South Texas Project Electric Generating Station P.O. Box 289 Wadsworth, Texas 77483

U7-C-STP-NRC-090074

South Texas Project  
Units 3 and 4  
Docket Nos. 52-012 and 52-013  
Response to Request for Additional Information

Attached are responses to NRC staff questions included in Request for Additional Information (RAI) letter numbers 76 and 89 related to Combined License Application (COLA) Part 2, Tier 2, Section 6.2 and Appendix 3B.

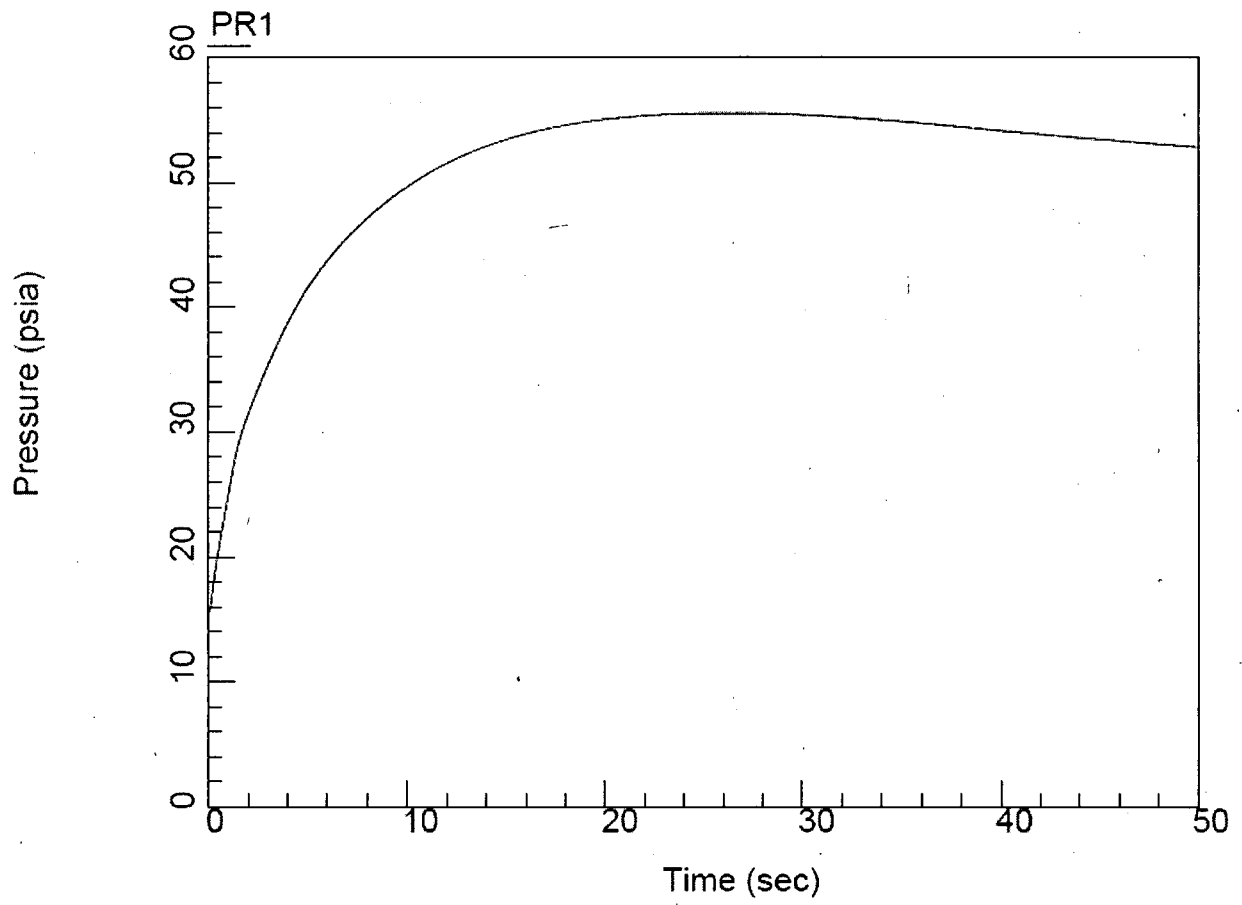
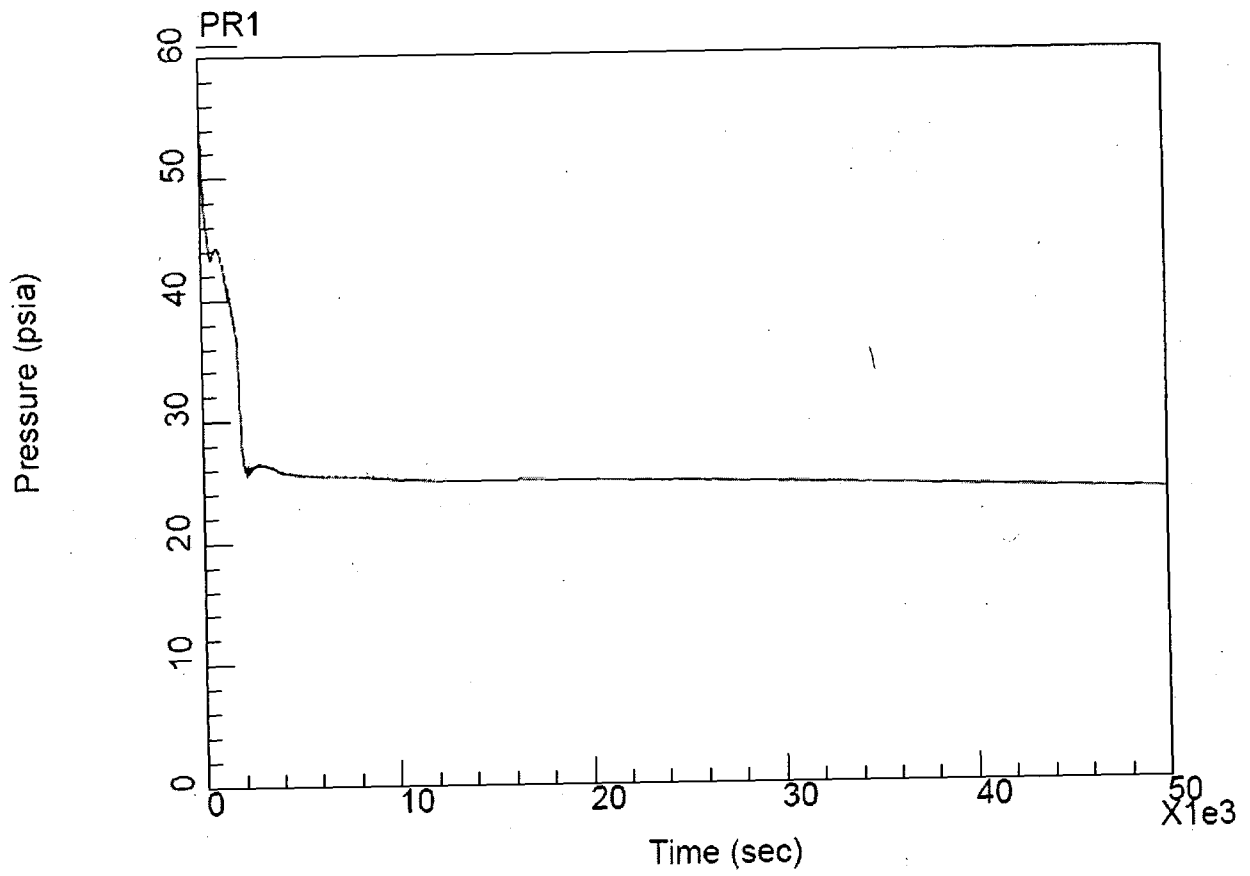
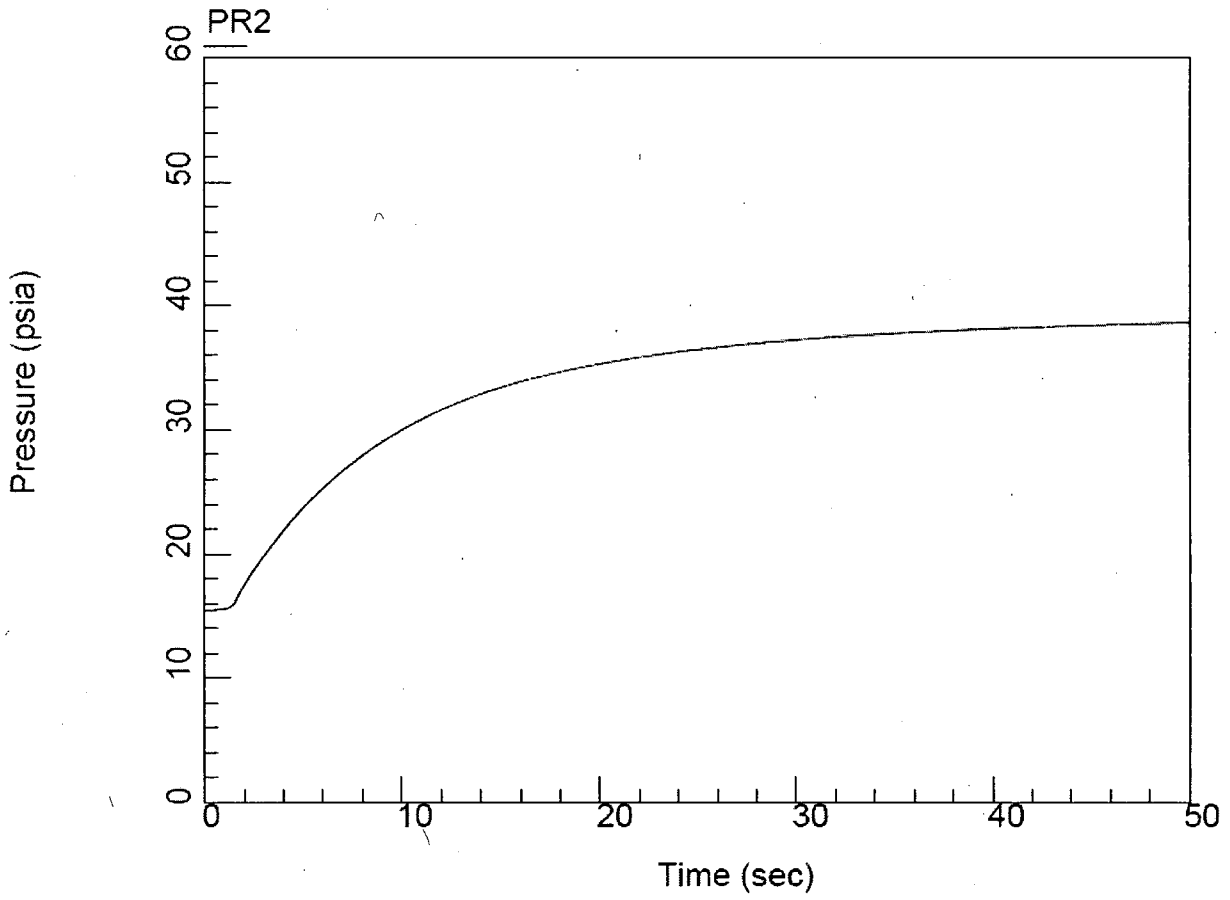
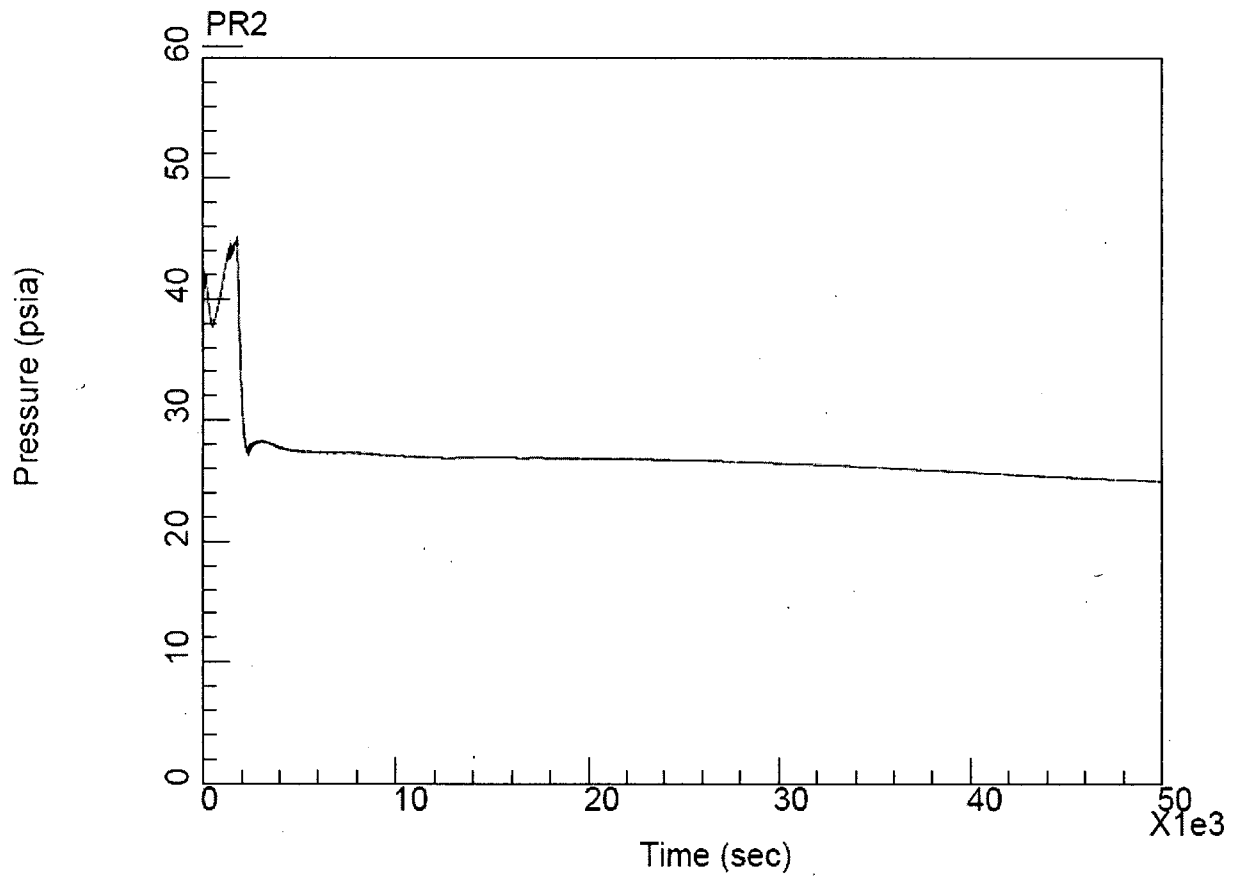
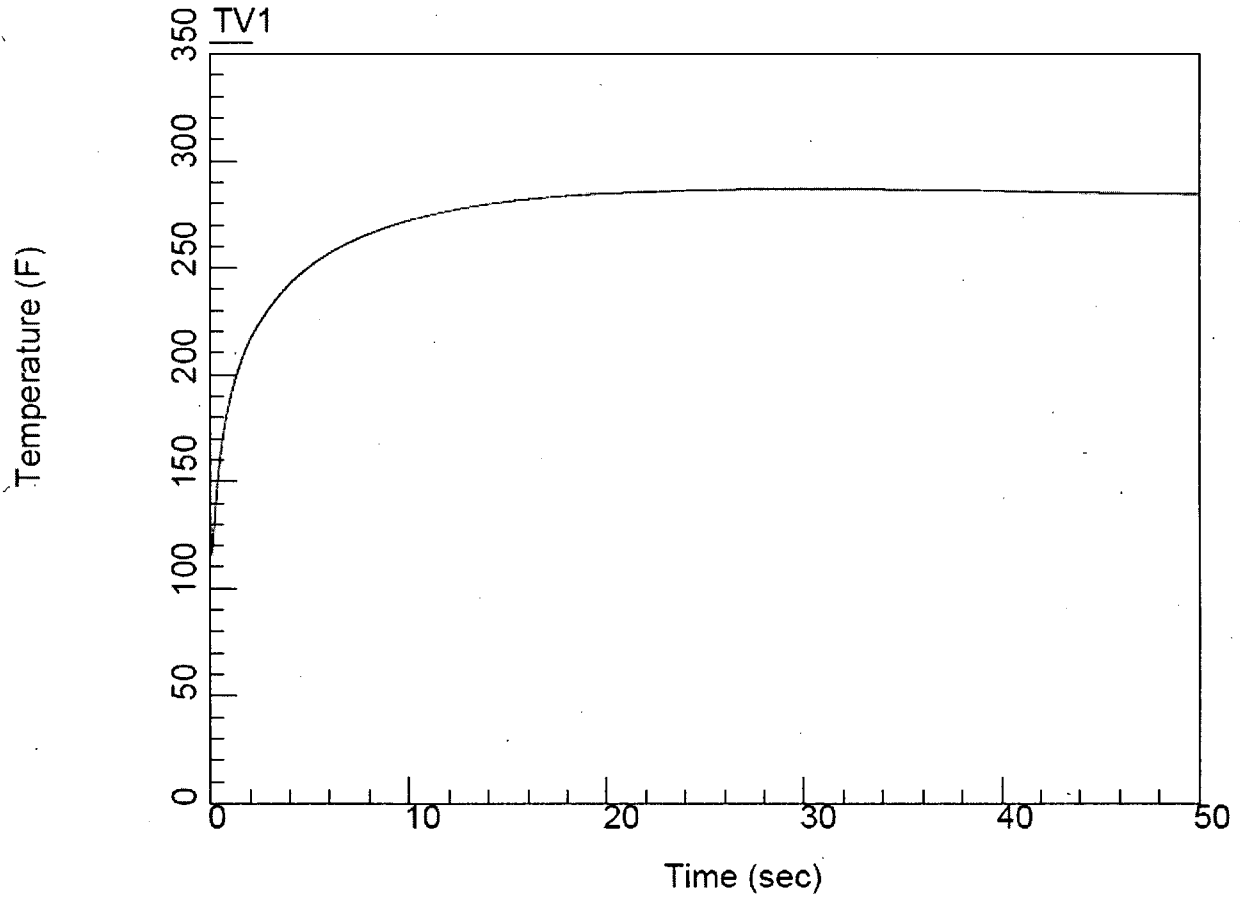
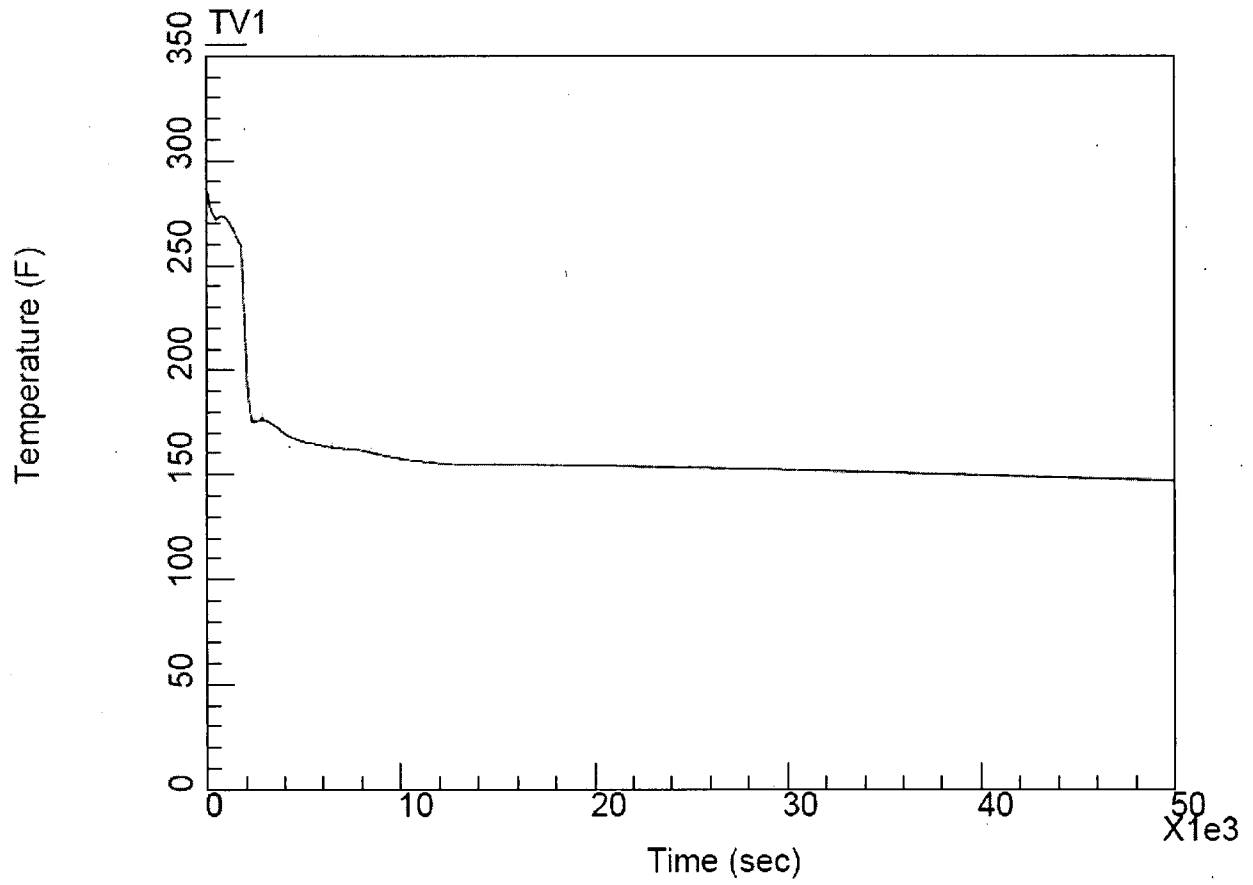
- (d) Feedwater Line Break (FWLB):
- A figure showing the containment pressure and temperature response (i.e., Figures 6.2-6 and 6.2-7 in [reference 2] STP COLA with the time axis varying from 0.0 to 30 min)

- (d) For the first bullet item, the requested FWLB figures and curves are provided in Figures 2 through 9. The figures provide results for both the short term (0-50 sec) and the long term (0-13.9 hours) analyses.
- For the second bullet item, the decay power curve in Fig. 6.3-11 is not used in the containment analysis but rather is used for the ECCS analysis. Consequently, the normalized power level for that Figure would not have any bearing on the containment analysis results. The decay power curve used for the containment analysis is based on 102% power.
- (e) The requested MSLB figures are provided in Figures 10 through 17. These figures provide results for both the short term and the long term analyses.
